# UNITED STATES PATENT AND TRADEMARK OFFICE

APPLICATION NO.	FILING DATE	FIRST NAMED INVENTOR	ATTORNEY DOCKET NO.	CONFIRMATION NO.
10/777,572	02/11/2004	David Burton	24,577-45CIP	6003

<b>Office Action Summary</b>	<b>Application No.</b> 10/777,572	<b>Applicant(s)</b> BURTON, DAVID	
	<b>Examiner</b> Shumaya B. Ali	<b>Art Unit</b> 3771

## DETAILED ACTION

Figure 2

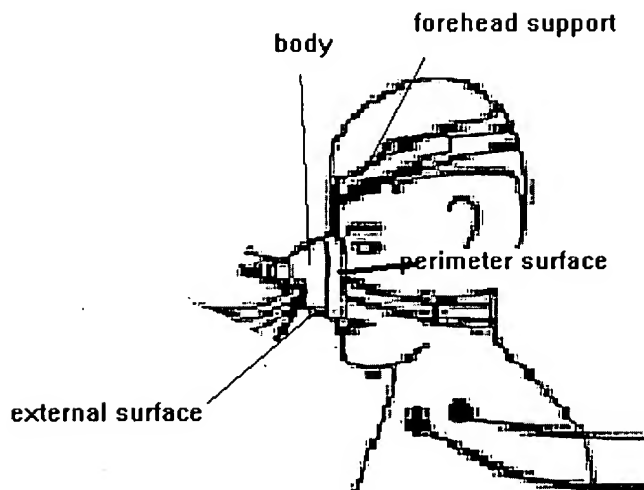
**As to claim 8,** Miles discloses a gas delivery system comprising a mask (see labeled fig.2, attachment below) having at least one physiological sensor (col.4, lines 55-60) connected (col.4, lines 43-45) thereto; a gas delivery device (fig.2,1) having an adjustable gas delivery setting (gas delivery adjustment is possible via 12), and a processor (fig.2, 12) in communication with the gas delivery device and the sensor, the processor is adapted to determine the existence of a sleep disorder and to adjust the gas delivery setting based thereon (see col.5, lines 26 and 27, lines 48-50, and col.6, lines 17-24).

**As to claim 14,** Miles discloses a gas delivery system comprising a mask (see labeled fig.2 attachment below) having at least one EEG sensor (col.4, lines 55-60) connected thereto, a gas delivery device (fig.2,1) having an adjustable gas delivery setting (delivery is adjusted via a processor 12 ); a processor (fig.2, 12) is communication with the gas delivery device and the

**As to claim 24**, Miles discloses an apparatus comprising a mask (see fig.2 attachment below) having a body position sensor (see col.4, lines 55-60) attached thereto (see col.4, lines 33-37), a processor (fig.2, 12) in communication with the sensor and adapted to determine body position from the body position sensor's output (see col.5 lines 20-68, and col.6, lines 1-30).

**As to claim 31**, Miles discloses a gas delivery system comprising a gas mask (see fig.2 attachment below) adapted to fit on a patient, a gas delivery device (fig.2,1) having an adjustable gas delivery (via processor 12, see fig.2), and a processor (fig.2,12) in communication with the gas delivery device (see fig.2) and a cardiac pacemaker (processor inherently communicate with a pacemaker via heart rate sensor, see col.6, lines 55-60), the processor

As to **claims 1**, Miles discloses a mask assembly (3,26) comprising a body (see fig.2, attachment below) having an internal surface (see fig.2, mask inherently have external and internal surface), an external surface (see fig.2, attachment below), and a perimeter surface (see fig.2 attachment below); and a forehead support (see fig.2 attachment below) connected to the body. Miles further discloses EEG sensor (see col.4, lines 55-59). Miles however lacks the forehead support having an EEG sensor (see col.4, lines 44-45; lines 55-59). However, Genger teaches a forehead support bar with sensor that reads brain activity (see fig.1, 9/10/11; see col.1, lines 20-22). Applicant's EEG sensor also detects brain activity. Therefore, it would have been obvious to one of ordinary skill in the art at the time the invention was made to modify Miles to

As to claim 6, Miles discloses a strap extending from the mask (see labeled fig.2 attachment below) and physiological sensors (see col.4. lines 33-35, lines 44-45; lines 55-59; col.5 lines 615, and col.7 lines 37-51), however, lacks said sensor is located on the strap. However, Brown teaches physiological sensors can be located on the strap (see fig.1f, 33). Therefore, it would have been obvious to one of ordinary skill in the art at the time the invention was made to modify Miles to change the location of the physiological sensor because it is known in the art as taught by Brown.

**As to claim 23**, Miles discloses a method of detecting oral or nasal breathing during nasal ventilation, the method comprising providing a mask adapted to form a seal between a patient's nose and mouth (seal is provided by straps, see fig.2 attachment below), the mask inherently having an interior surface and an exterior surface, the mask also having a first thermal sensor (see col.4, lines 55-60) on the interior surface (see col.4, lines 33-37) and a second thermal sensor (see col.4, lines 33-37). Miles however does not disclose the thermal sensor is located on the exterior surface to be adjacent the patient's mouth. Brown however teaches thermal sensor can be located on strap (see fig.1f, 33). Therefore, it would have been obvious to one of ordinary skill in the art at the time the invention was made to modify Miles to change the location of the physiological sensor because it is known in the art as taught by Brown. Miles further discloses detecting a temperature change (via processor 12, see fig.2) in the first or second thermal sensor (see col.5, lines 20-68, and col.6, lines 1-30). Thus, it would have been obvious to obtain the method steps of claim 22 using the device of Miles as modified by Brown.
